Sharktooth Bluffs Basin Storm Drainage Master Plan September 2019

RE: Sharktooth Bluffs Basin Storm Drainage Master Plan

ICON Engineering, Inc. is pleased to submit the Final Conceptual Design Report for the Sharktooth Bluffs Storm Drainage Master Plan. This submittal includes revisions to the report based on comments received on the DRAFT Conceptual Design Report.

Sharktooth Bluffs Basin Masterplan								
Comment and Response Tracking								
Draft Baseline H+H Report								
No.	YOUR NAME (last name, first name)	SECTION #	PAGE	LINE	COMMENT	S, R, E (Substantive, Requested, Editorial)	A, R, C (Accepted, Rejected with explanation, Needs Clarification)	RESPONSE (by consultant)
27	Fisher, Andrew	Study Area Map	7	Figure 2.1	Please add Long Range Growth boundary to map as well, if it can be depicted clearly. This may require a Study Area Map for present day boundaries and a separate map for future forecasted boundaries.	R		A vicinity map was added to show the LRG boundary in relationship to the Sharktooth Bluffs Boundary
28	Fisher, Andrew	Subwatershed Map	8	Figure 2.2	Please increase the size of Tributary labels to the size of the Jones Ditch and No.3 canal at minimum	R		Size has be

Figure 3.1 - SWMM Peak Flow
Discharge

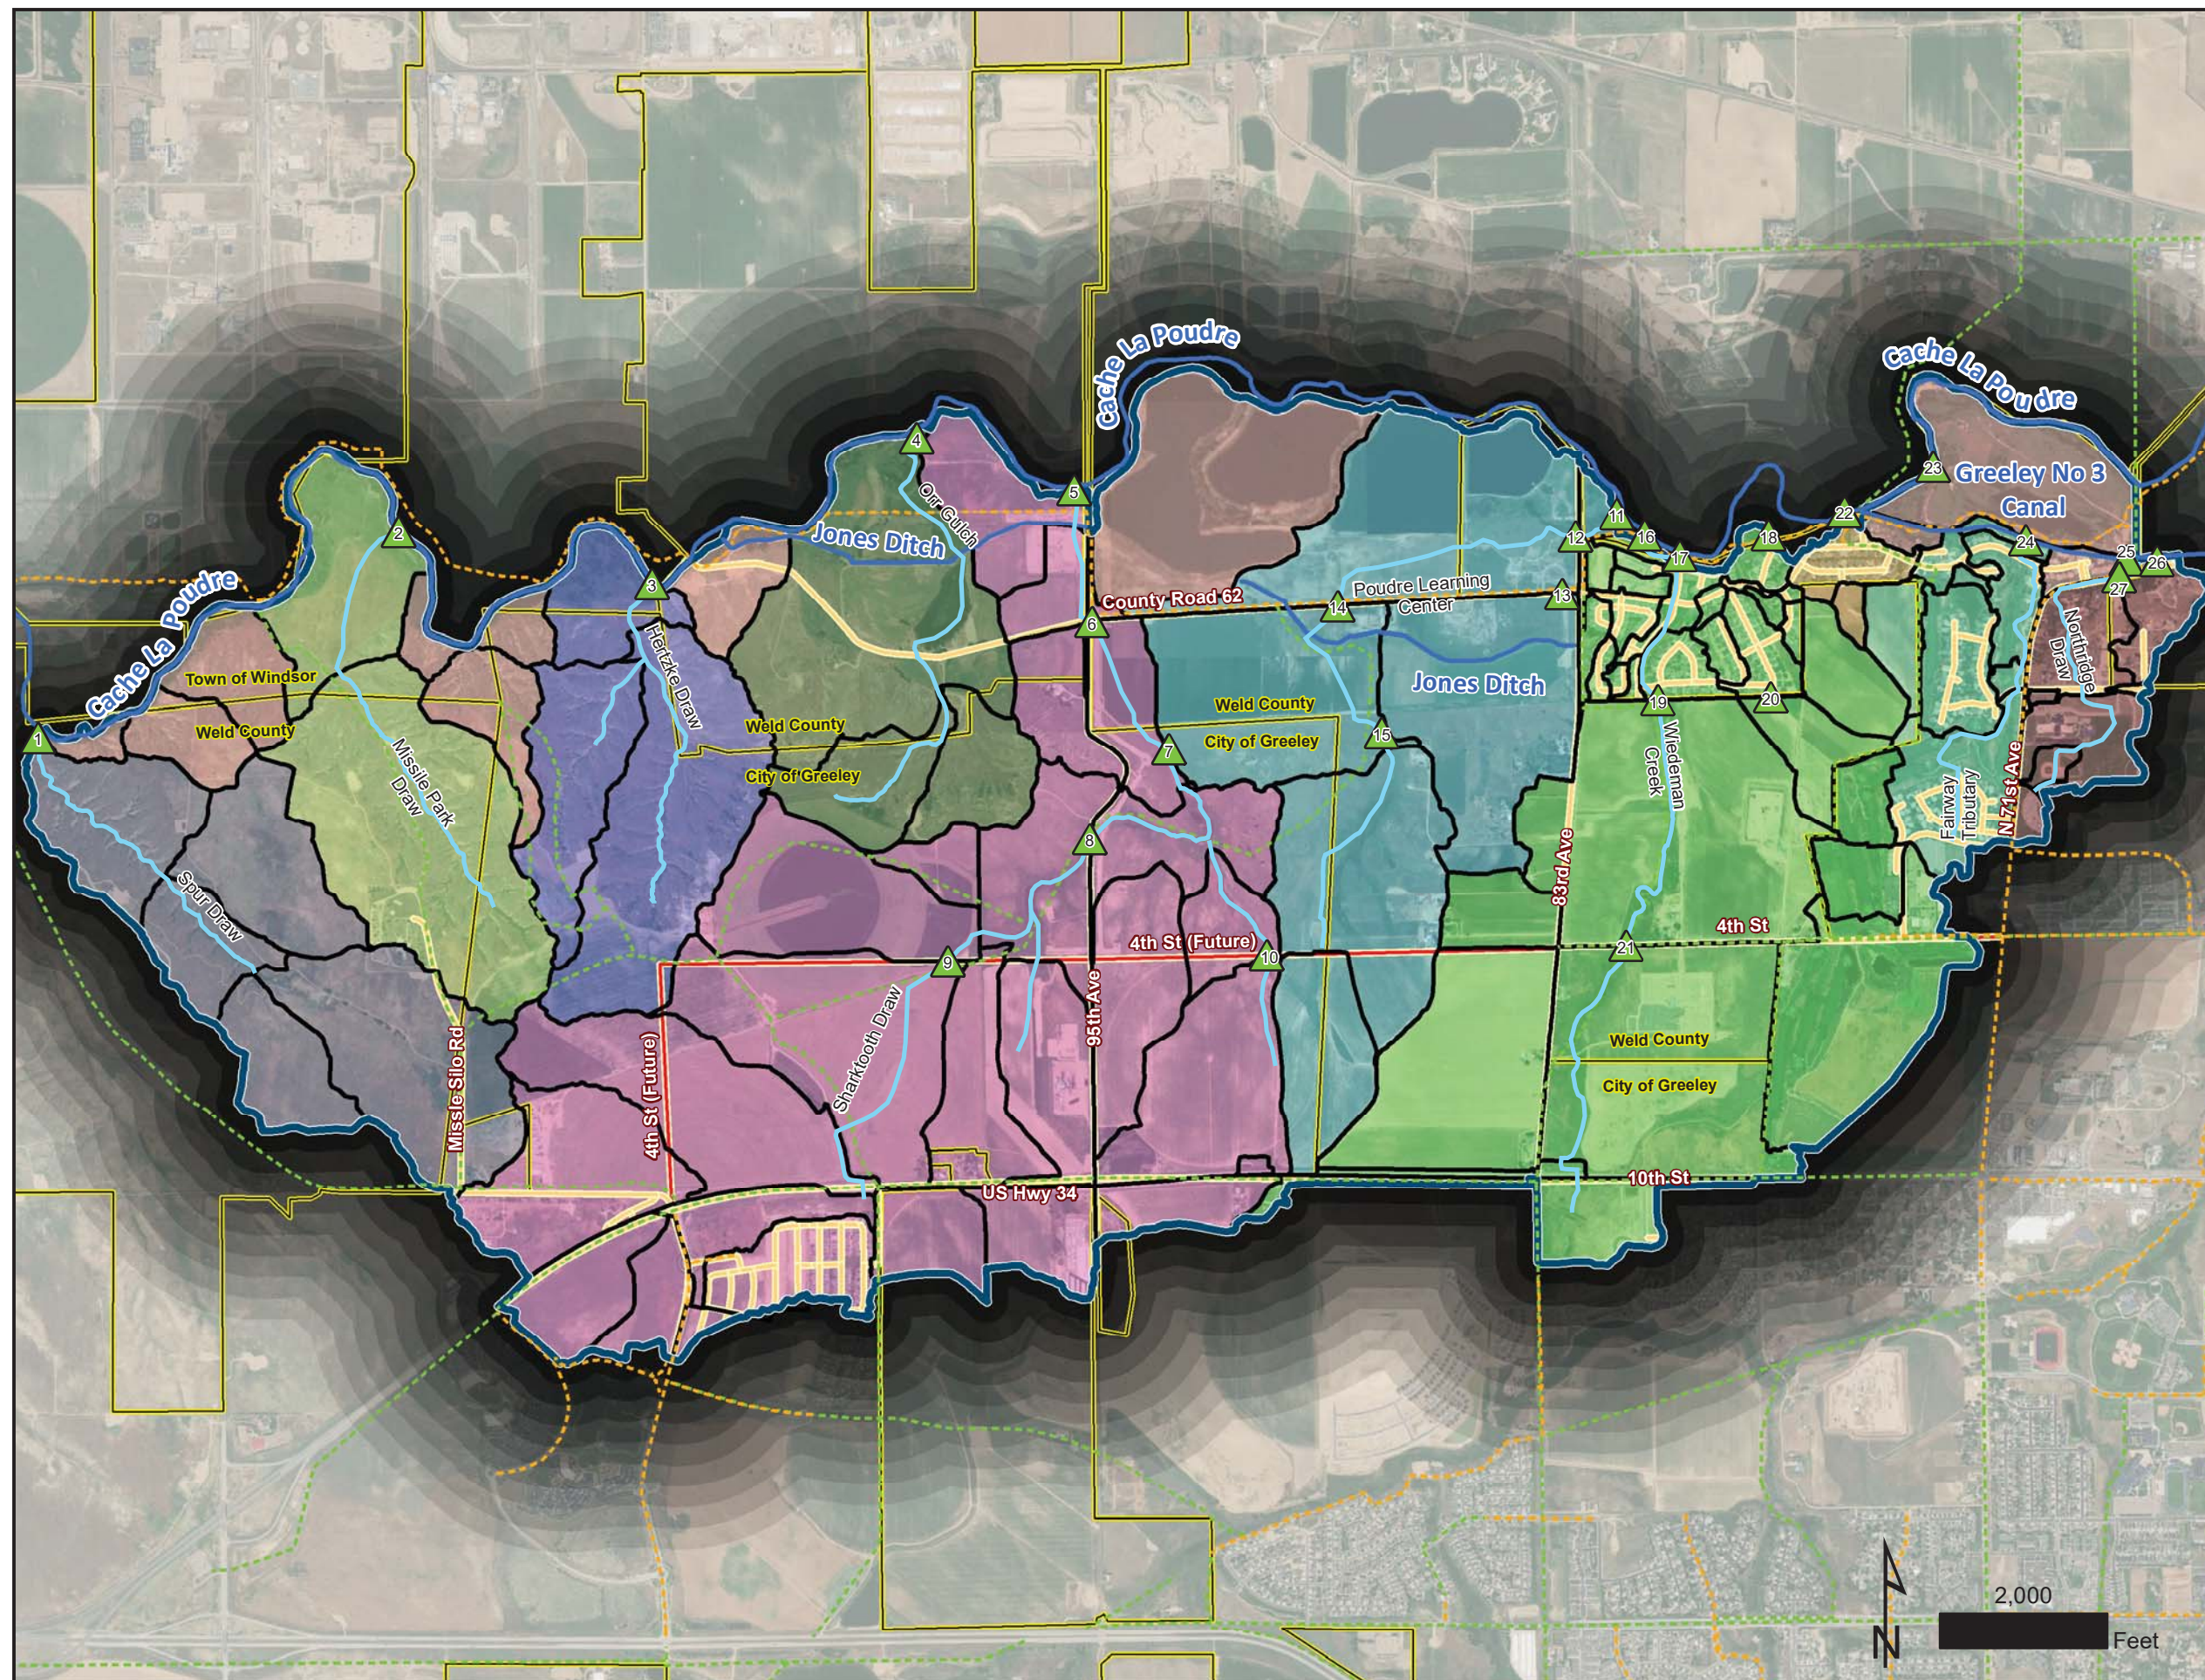
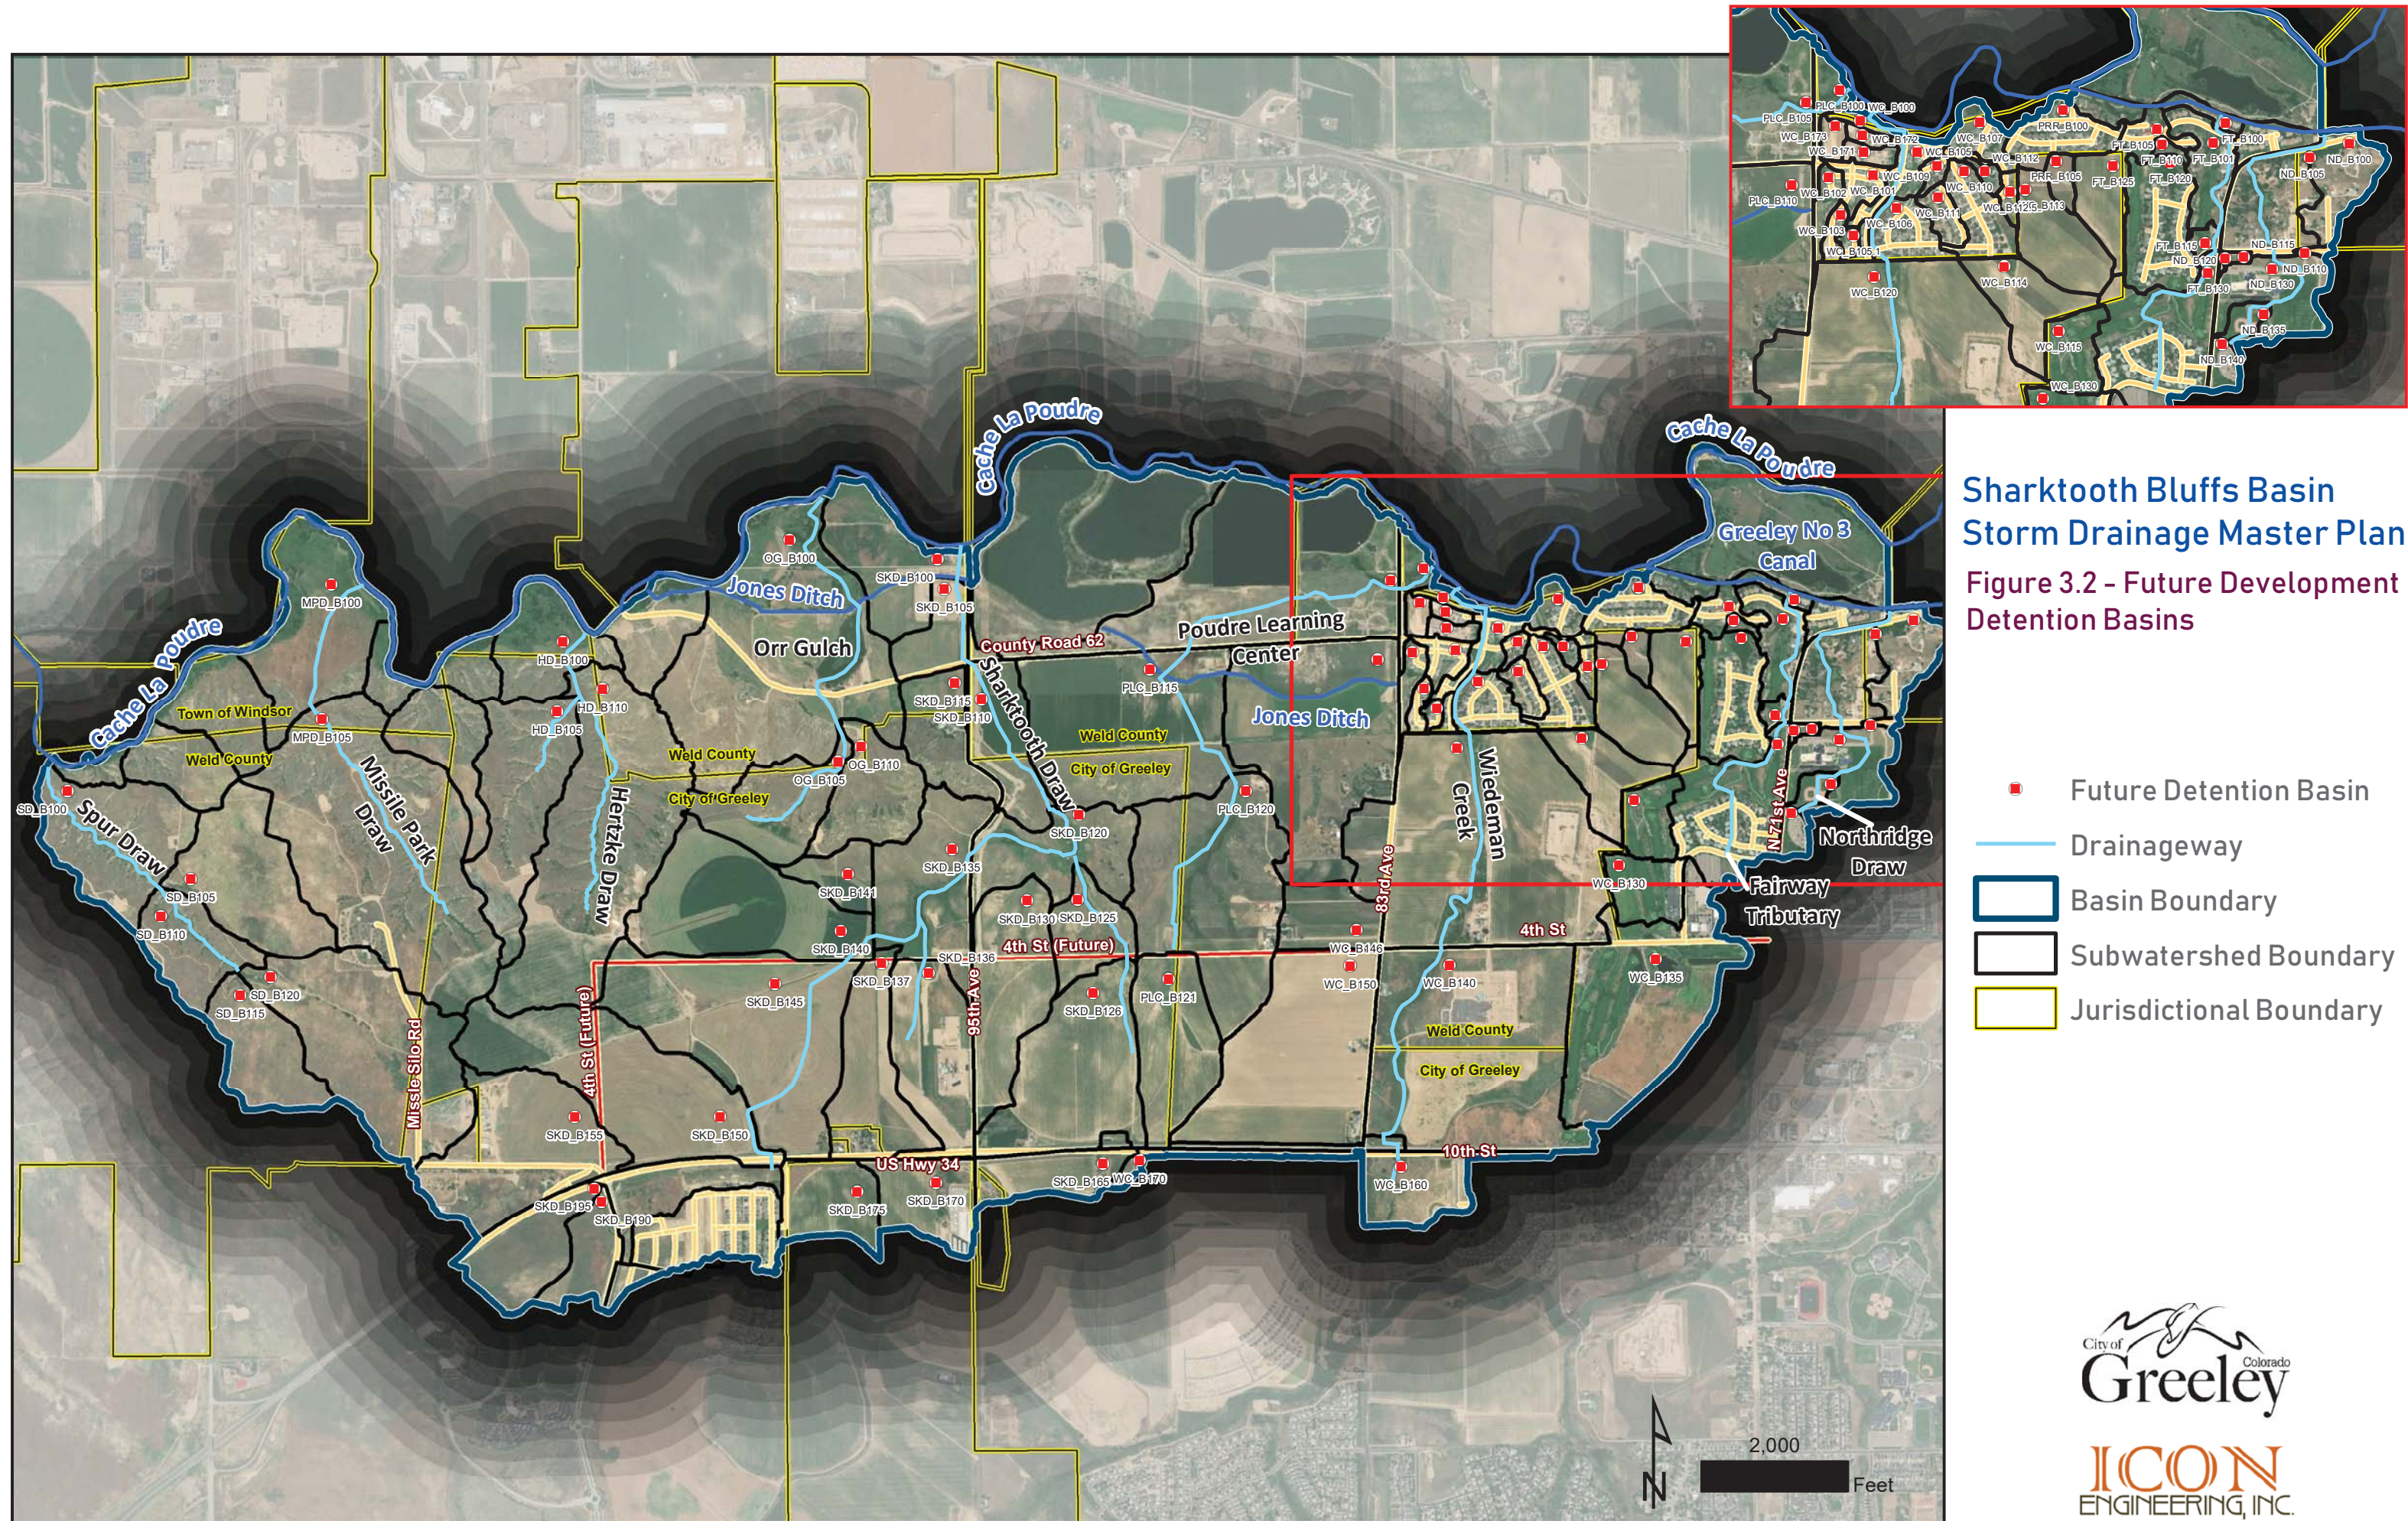
36	Fisher, Andrew	3.5.3	10	9	Add comma as noted	E	A	Comment addressed
37	Fisher, Andrew	3.5.3	10	11	Add "likely" as noted. Disruption not guaranteed by development	R	A	Comment addressed
38	Fisher, Andrew		12	Figures 3.1, 3.2	Please display the Figures in the same order they are initially mentioned in the report. This appears to be preferred to have Detention Facility Locations first and Peak Flow Design Points second based on the wording	R	A	Figures have been revised to reflect the order they are mentioned in the report
39	Fisher, Andrew		12/14	Figure 3.1	Please add Long Range Growth boundary and future trails alignments	R	A	Long Range Growth Boundary has been added
40	Fisher, Andrew		13	Table 3.3	There are frequent instances of increased peak flows from existing to future year conditions. Please speak to these, particularly for the Northridge and Poudre River Ranch watersheds that are predominantly developed already. Is detention required to increase beyond what is presented?	S	A	Table has been revised to accurately reflect detaining all future conditions discharges to historic 5 yr release rates as required by Greeley criteria
